PLANNING DIRECTOR'S SPECIAL PERMIT
1231 "I" STREET, SUITE 200, SACRAMENTO, CA 95814

C. Planning Director's Special Permit to allow 100 percent office in a proposed 6,500 square foot building on 1.0± vacant acres in the Light Industrial (M-1) zone.

APPLC.NO. P92-247

California Cascade Office Building/ P92-247

SK-1

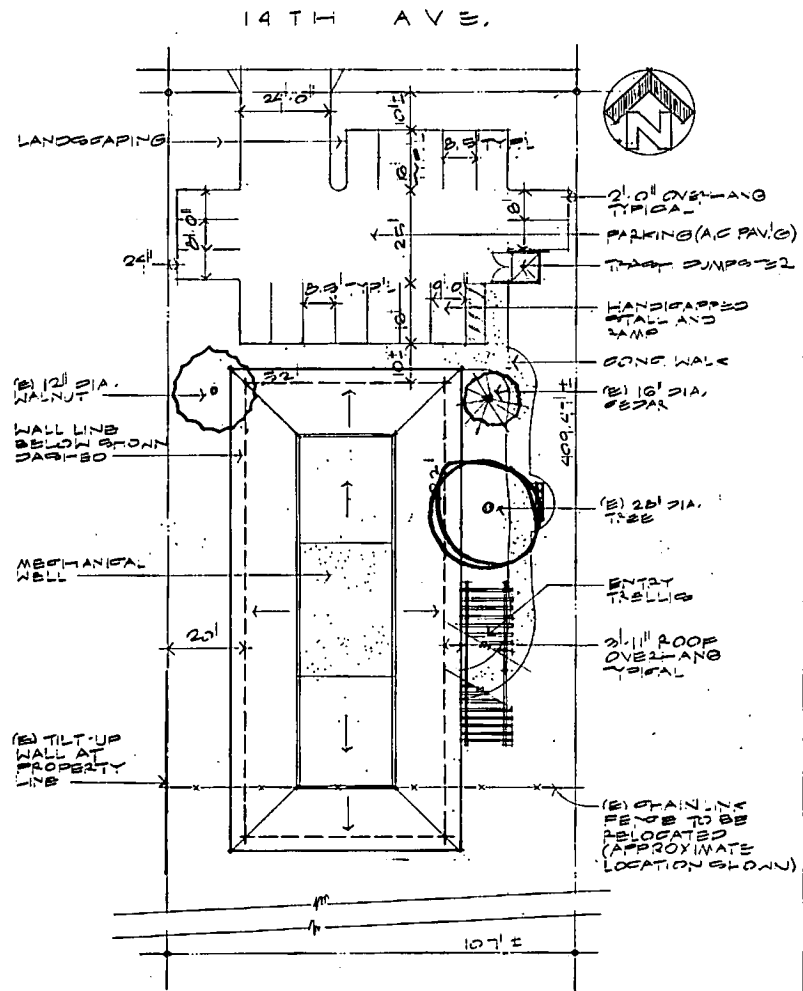
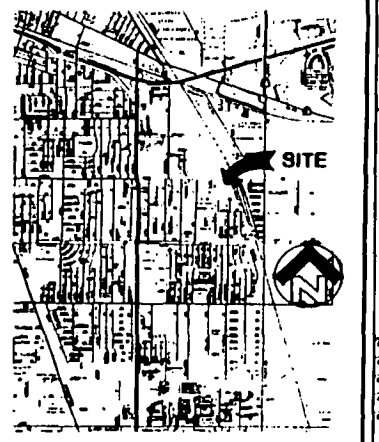
The submitted site plan indicates a minimum 10 foot landscape strip along 14th Avenue, with some areas consisting of 26 feet of landscaping. Adjacent to the landscaping is the proposed 18 space parking area. The site plan indicates 25 feet of maneuvering. The Zoning Ordinance requires 26 feet of maneuvering area. The two easterly parking stalls are difficult to maneuver out of, as well as the trash enclosure. The trash enclosure should be placed on the west side of the parking lot to eliminate the need for the trucks to back out of the lot. The trash enclosure should also be surrounded by a landscaped planter, as required by the Zoning Ordinance, as well as meet the requirement of the Recycling Ordinance.

The submitted site plan indicates a 10 foot wide walkway provided between the parking area and the building. Staff suggests there be a minimum four foot wide planter between the parking area and the building. The applicant should submit a revised site plan and a landscape plan for review and approval of the Planning Director prior to the issuance of Building Permits.

1. The two east-west parking spaces on the east end of the parking lot do not have adequate back-out maneuvering room and should be removed.
2. Provide adequate maneuvering room for all parking spaces.
3. The location of garbage dumpster forces trucks to back-out onto 14th Avenue.
4. Dedicate five feet additional right-of-way along 14th Avenue and construct sidewalk.

- 1. The applicant shall submit a revised site plan and landscape plan for Planning staff review and approval which indicates the following:
 - a. the required 26 feet of maneuvering area;

- b. adequate maneuvering for the two easterly parking stalls;
 - c. ✓the trash enclosure placed on the west side of the parking lot;
 - d. the trash enclosure surrounded by a landscaped planter; and

- e. a minimum four foot wide planter between the parking area and the building.
- 2. The applicant shall submit a Recycling Plan to comply with the requirement of the Recycling Ordinance.

ELEVATIONS

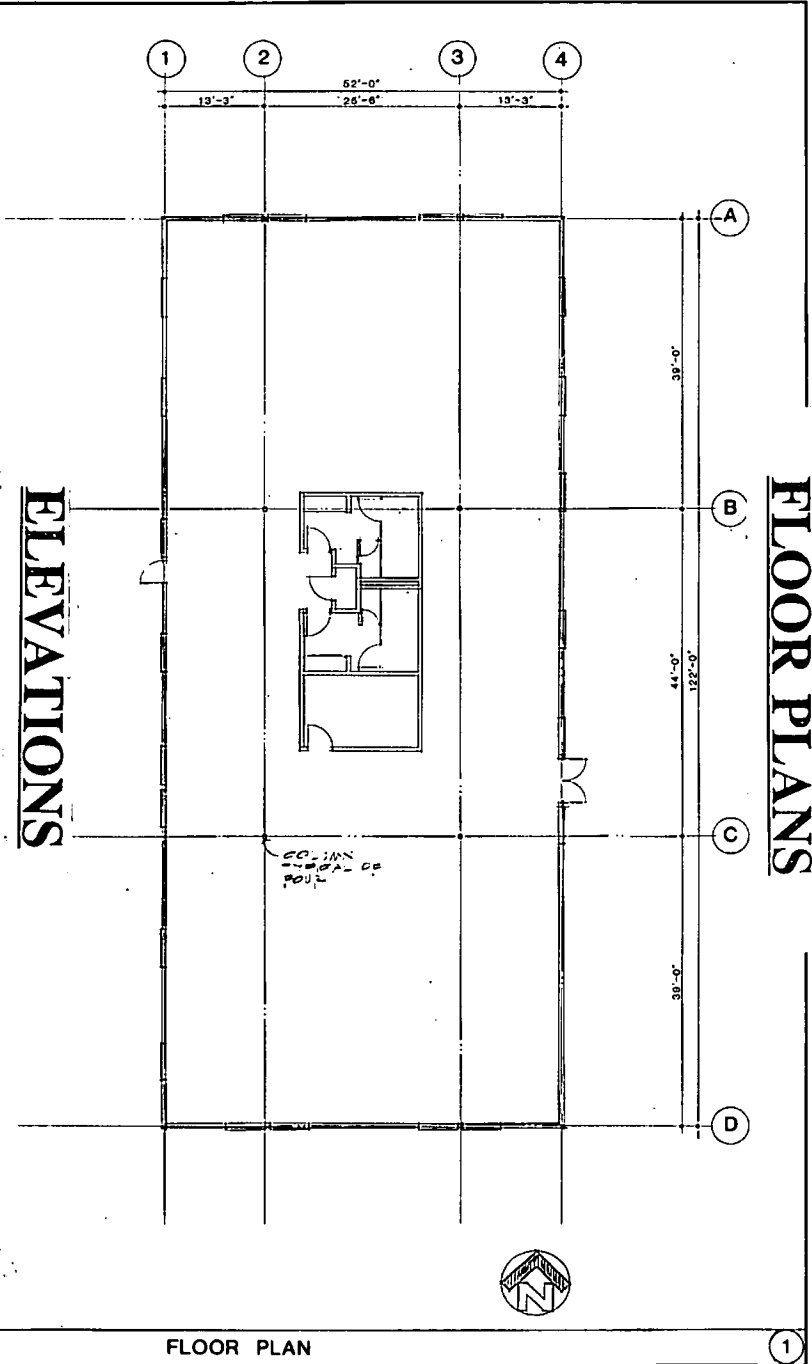
The applicant is proposing to construct a single story, 6,500 square foot office building. The applicant is proposing to use stucco on the south side of the building with plywood siding on all three other elevations. The roof material is proposed to be composition shingle. Staff suggests the use of stucco on all elevations of the building. The roof material should consist

of concrete tile or wood shake. The applicant should submit revised elevations for review and approval of the Planning Director prior to the issuance of Building Permits.

- 3. The applicant shall submit revised elevations for review and approval of the Planning staff prior to the issuance of Building Permits which indicate the following:

- a. the use of stucco on all elevations of the building; and
 - b. the roof material of concrete tile or wood shake.
- 4. The applicant should be aware that at the time of Building Permits, dedication of five feet additional right-of-way along 14th Avenue and construction of the sidewalk will be required.

DATE	8.31.82
SCALE	1/8" = 1'-0"
DRAWN	
CHECKED	
PROJECT	SK-2
SHEET	1 OF 2

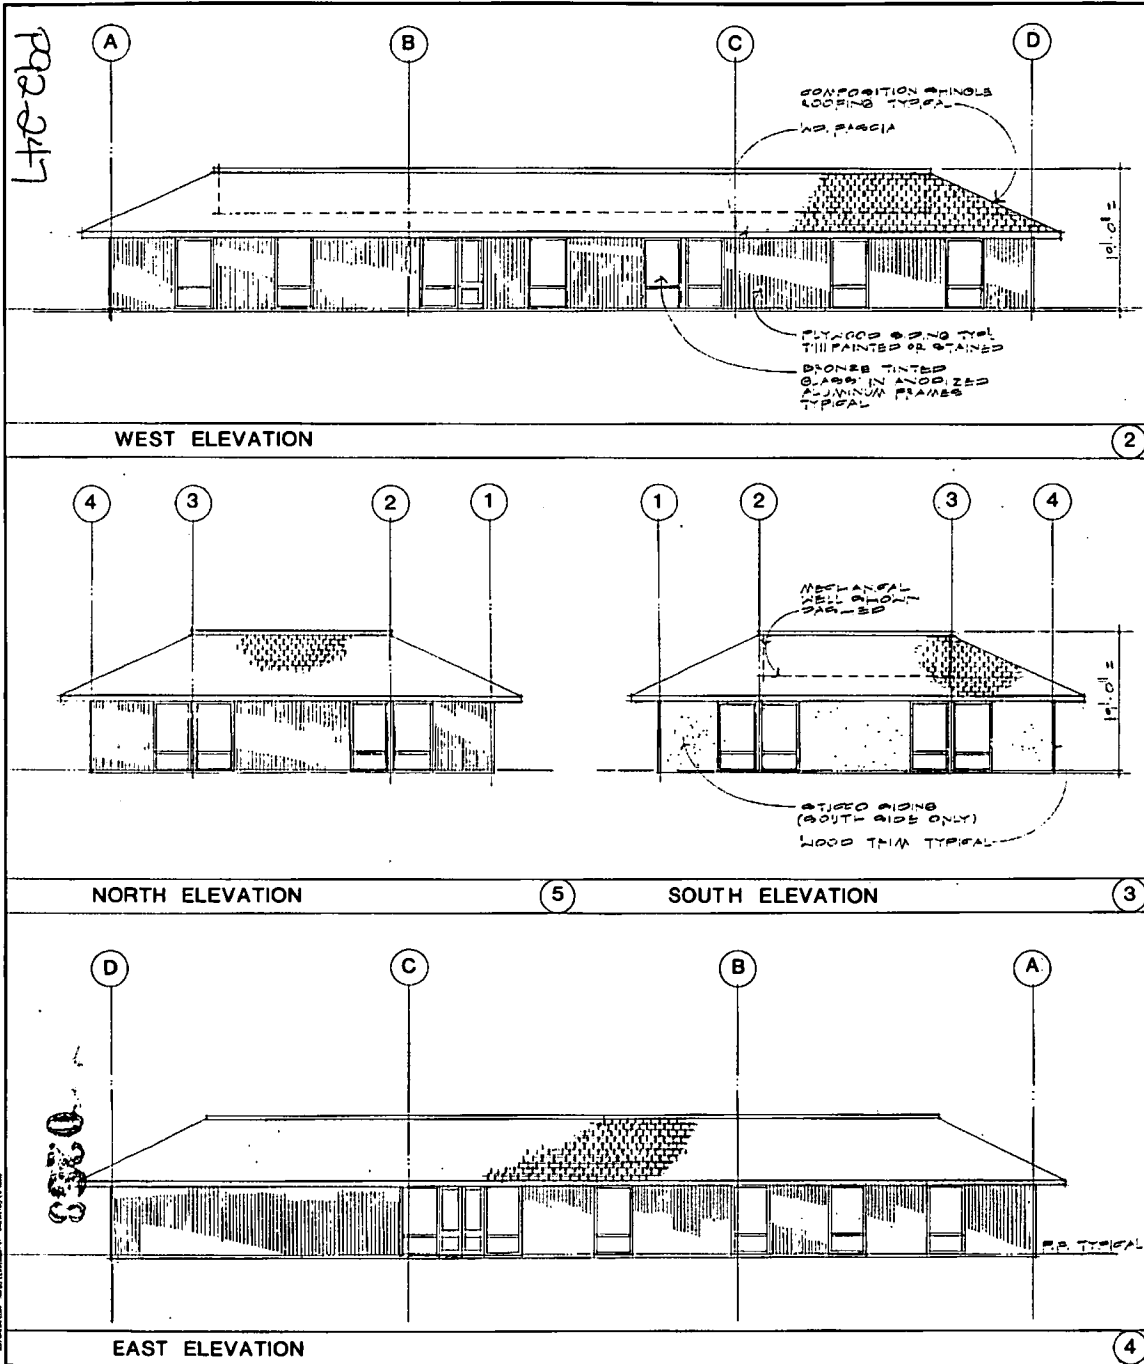
The submitted floor plan (SK-2) does not comply with current requirements. The distance between the two exits shall be not less than one half of the diagonal of the area to be served.
